Detroit
Edison

Reference: Enrico Fermi Atomic Power Plant Unit 2
NRC Docket 50-341

Subject: Responses to Questions from Gerry Mauch

FIGURE H.II.K.3.18-2

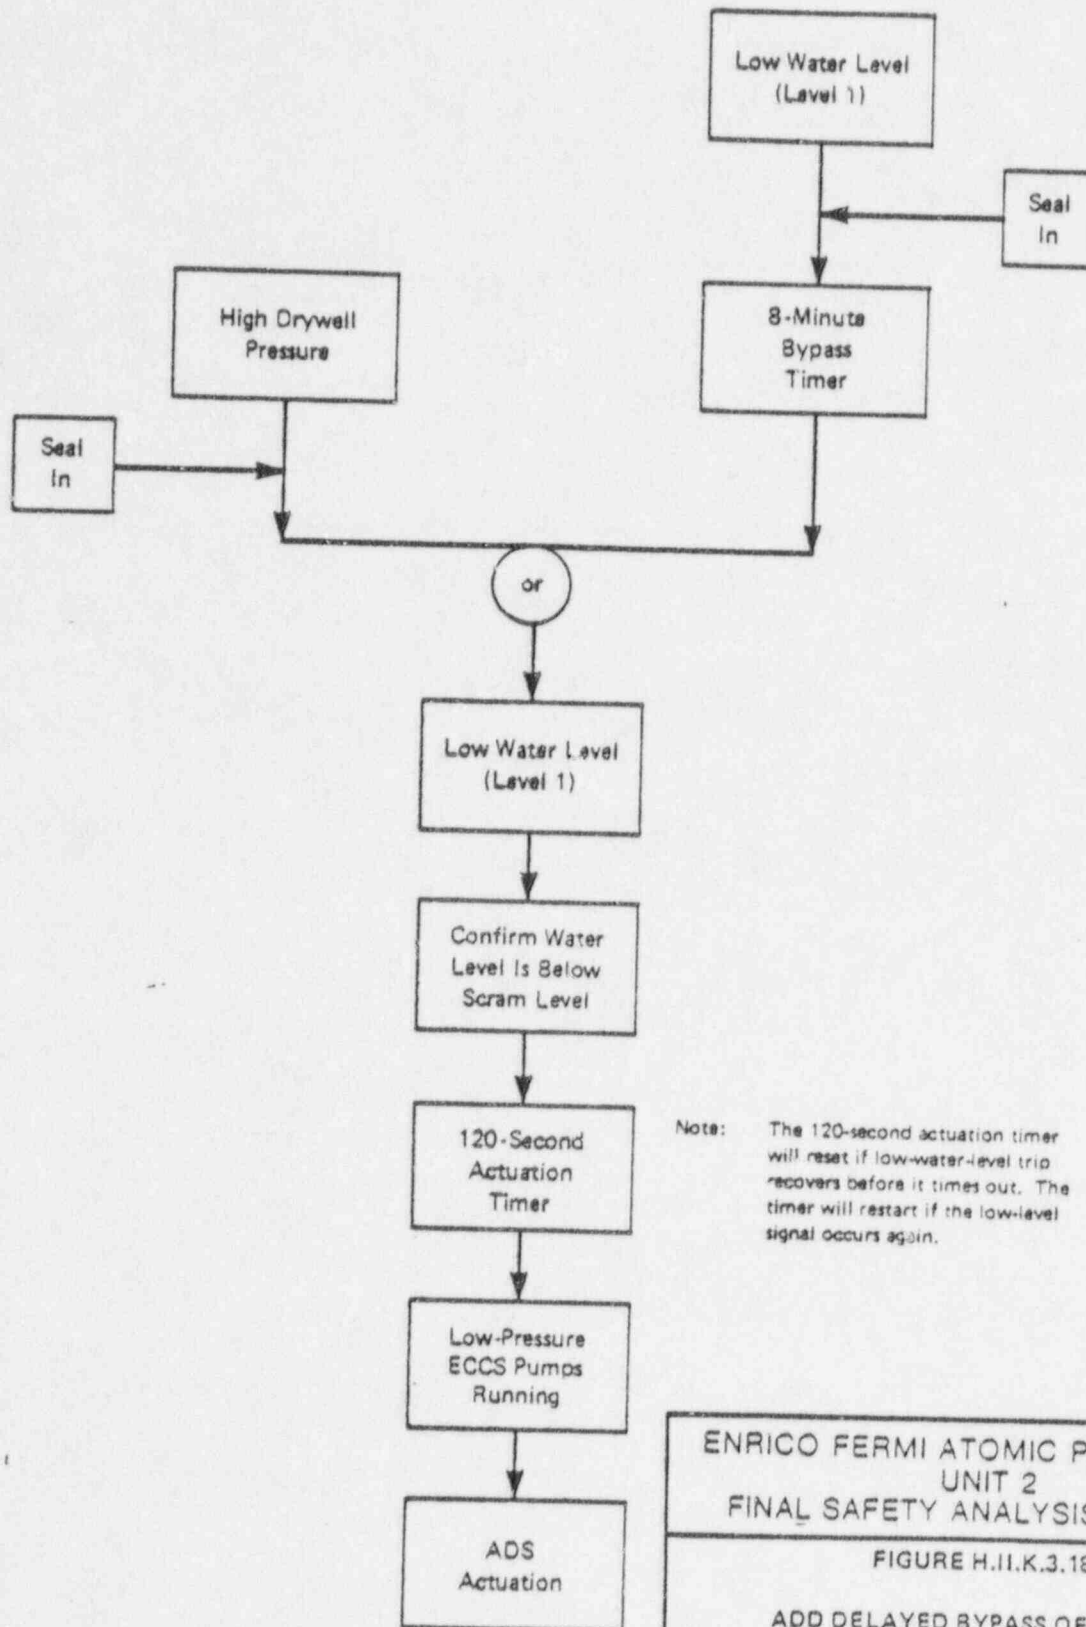
At the I&C exit interview, the staff reviewer requested that the specific design modification to the ADS initiation logic be identified, the attachment indicates clearly the method being employed to mitigate this concern.

Of the two alternatives recommended by the BWR Owners' Group study, the addition of a bypass to the high drywell pressure trip if the reactor water level remains below the low-pressure ECCS initiation setpoint for a sustained period, is judged to be the preferred solution.

This will be accomplished by installing a "bypass" timer activated on low water level (Level 1). When this timer runs out, the high drywell pressure trip is bypassed and the ADS is initiated on

35 Figures H.II.K.3.18-1 and H.II.K.3.18-2 show the logic for this alternative, with the bypass timer started on Level 1. A time delay of 8 minutes has been chosen for the Fermi 2 plant from the analyses presented in NEDO-24708 (Figure Group 3.5.2.1-33). The results of these analyses demonstrate that adequate core cooling is ensured for isolation events, even with the ADS blowdown delayed 10 minutes after Level 1. Figure Group 3-1 shows the same analysis assuming a stuck-open relief valve.
